Enclosure 4

TAC 15-002

Safety Analysis Report Page Markups

Figure 2-5. Topography Contour of Vallecitos Nuclear Center

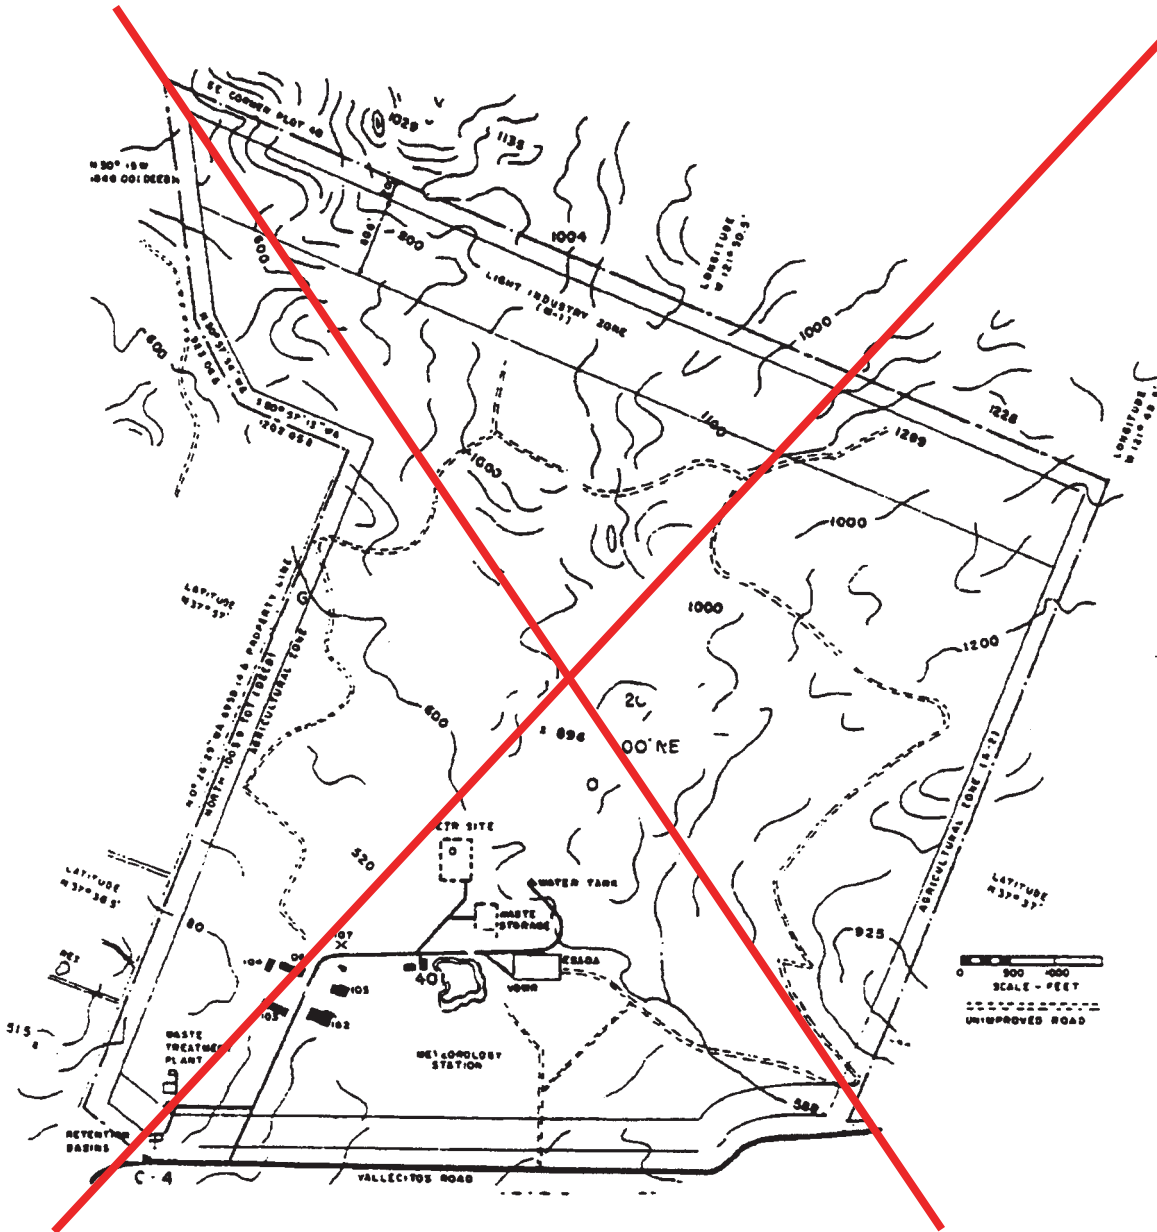
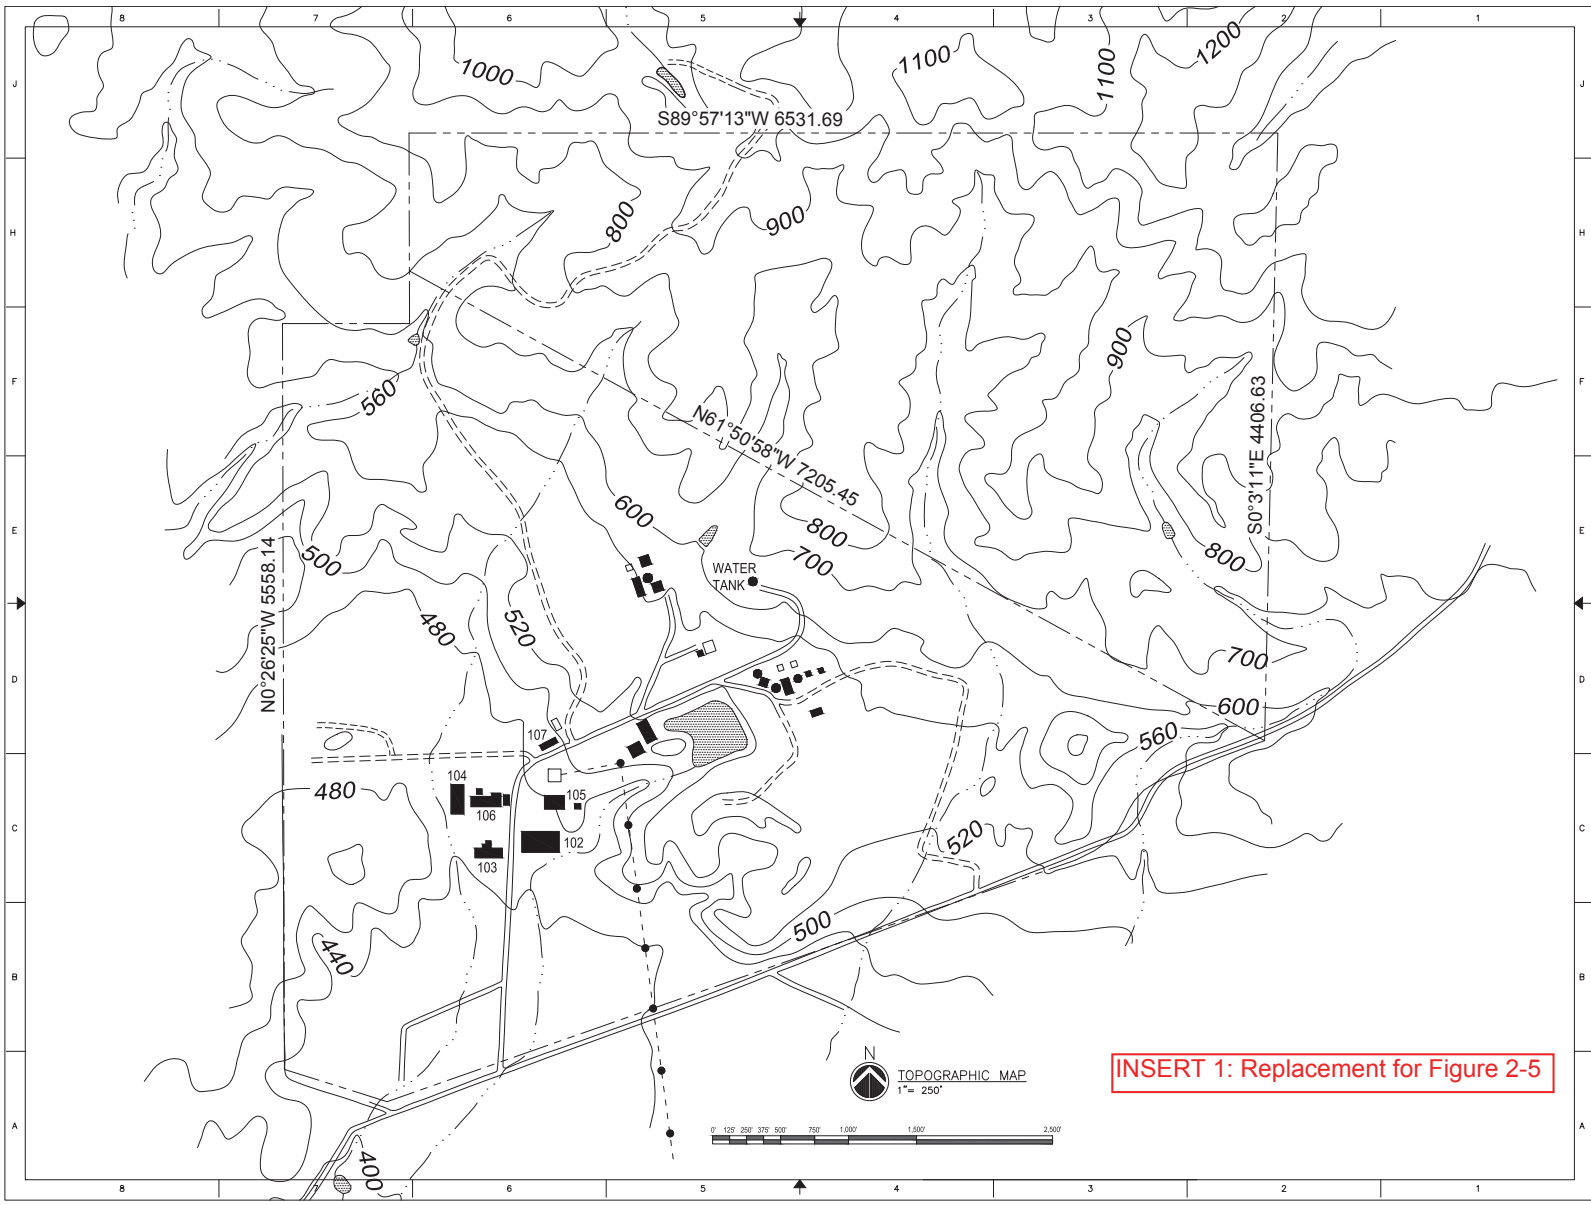
Replace this figure with INSERT 1 (next page).

INSERT 1: Replacement for Figure 2-5
